**Subject: MHI's Responses to US-APWR DCD Draft Open Item SRSB 5.4.12**

Responses to Draft Open Item SRSB 5.4.12 Revision 0

**OPEN ITEM NO.:** SRSB 5.4.12  
**SRP SECTION:** 05.04.12- REACTOR COOLANT SYSTEM HIGH POINT VENTS  
**APPLICATION SECTION:** 5.4.12  
**DATE OF RAI ISSUE:** 6/2/2009

Figure-1 Operation procedure of RV vent valves

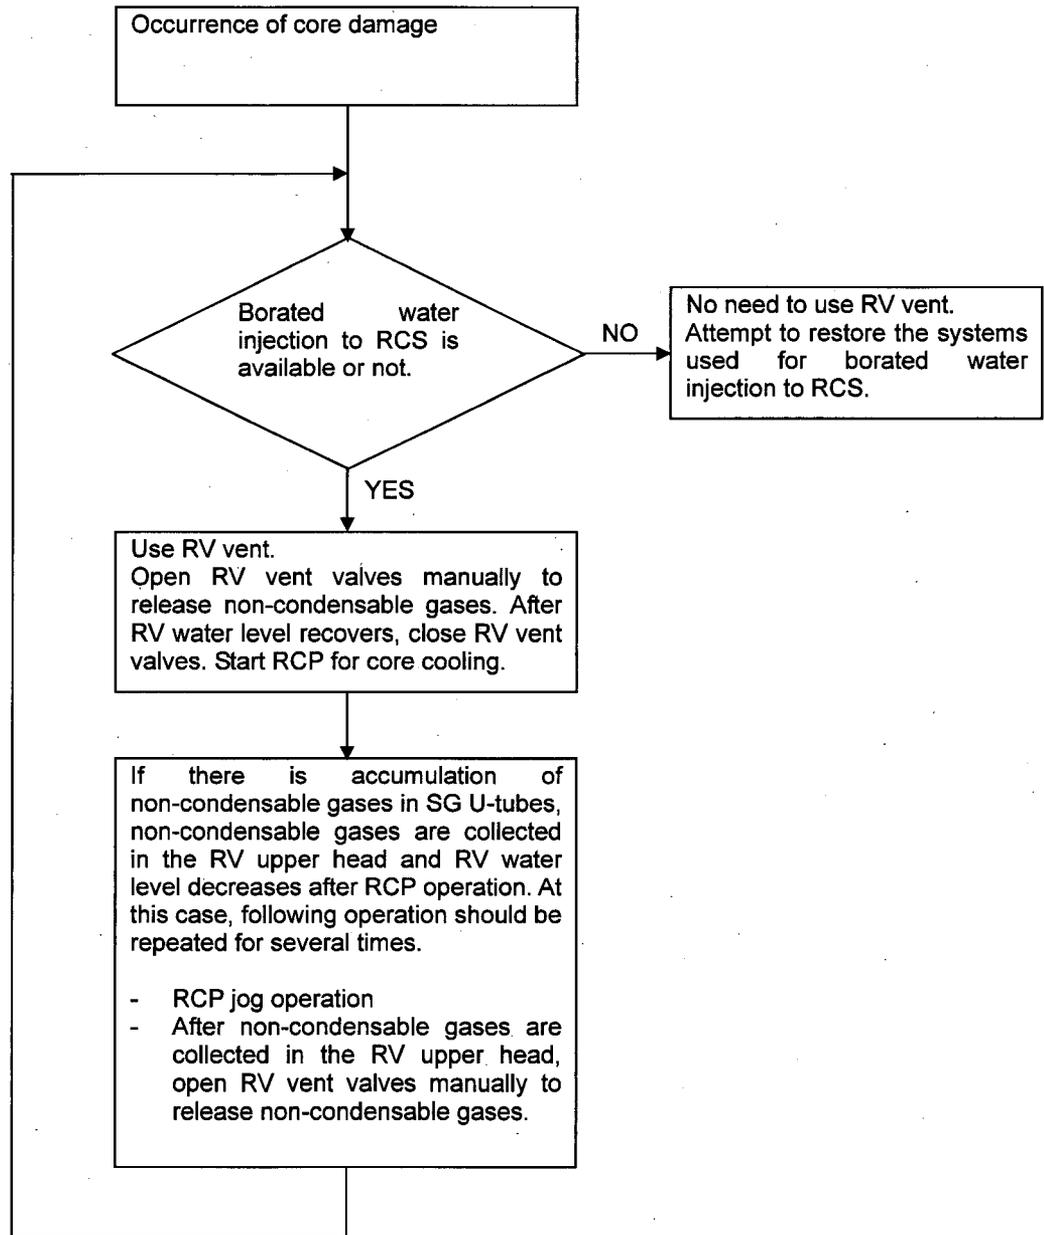
The acceptance criteria of Section 5.4.12 of the SRP specify that procedures should be developed to use the vent paths to remove gases that may inhibit core cooling from the U-tubes of the SGs. In addition, the procedures to operate the vent system should consider when venting is needed and when it is not needed, taking into account a variety of initial conditions, operator actions, and necessary instrumentation). In response to the staff RAI 5.4.12-5 (RAI 48-840 dated 8/11/08; MHI response dated 9/22/08) regarding the need of operating procedures for the RCS high point vent system, MHI provided discussion on the high level guidelines for the required operating procedures. However, detailed operating procedures have not made available for the staff review. If MHI could not provide detailed operating procedure for the RCSHPVS in response to the staff RAI 5.4.12-5, the staff will accept that MHI propose a COL action item to require COL applicants to provide detailed operating procedures in their applications to fulfill this acceptance criterion.

The operation procedure is shown in Figure-1. Whatever the initial condition may be, non-condensable hydrogen gases can accumulate in the RV upper head as long as break size of the RCS boundary is small or in-vessel-retention is achieved. If RV vent operation is judged to be effective for core cooling, operator manually opens the RV vent

valves and removes non-condensable gases from the RV upper head. After RV water level recovery, operator manually closes RV vent valves. If non-condensable gases accumulated in SG U-tubes exist, they are collected in the RV upper head and RV water level decreases after RCP operation. At this case, RCP jog operation and RV vent should be performed several times manually by operator to remove non-condensable gases accumulated in SG U-tubes.
